**ENVIRONMENTAL STATEMENT
INTERMOUNTAIN POWER PROJECT
US Department of the Interior
Bureau of Land Management**

INTERMOUNTAIN POWER PROJECT
ENVIRONMENTAL STATEMENT
FINAL
VOLUME IV

SECTION 2--CHAPTER 9
PUBLIC COMMENTS AND RESPONSES

CHANGES OF FIGURE 2-18
FIGURE 2-16
2-36
2-42

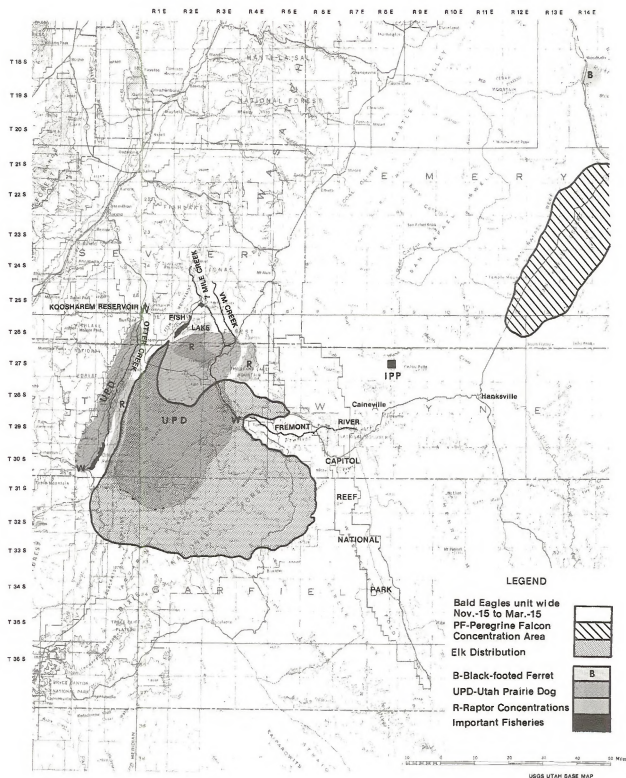
- 15 Page 2-41, Terrestrial Wildlife. Distributions of big game in Figure 2-16 are reasonably accurate for those shown; however, not all big game distributions in the regional setting are shown. Similar comments apply to Figure 2-18 in relation to threatened and endangered species, raptor and waterfowl distributions.

30.15 Response: Only those big game, threatened and endangered species, raptor and waterfowl distributions which could be materially affected by the proposal are depicted on Figures 2-16 and 2-18. Although general in nature they were designed to provide only for the general distribution of the more significant species of animal life likely to be impacted by the proposal. More detailed information is available in the Richfield District Office files.

CHANGES OF FIGURE 8.2-13
& FIGURE 8.2-14

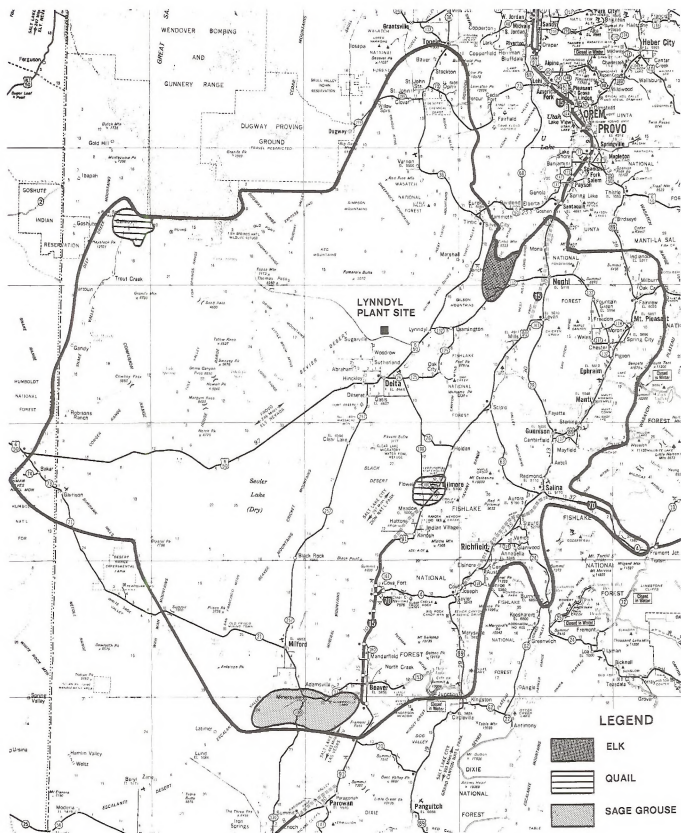
Figure 8.2-14 - fails to identify that:

Figure 8.2-13 - fails to identify that

16.2 Response: Figure 8.2-13 has been altered to include the elk area on the East Tintic Mountain. Revised figure is shown as "Changes of Figures 2-13 and 2-14" in the Addendum. This does not affect the discussion of impacts on big game presented on Page 8.3-23, which states that more hunting could reduce big game populations in Central Utah, because elk expansion into this area would not be affected by hunting for several years and then it would be restricted by UDMR.

16.5 Response: Figure 8.2-13 has been changed. See Letter 16 Response
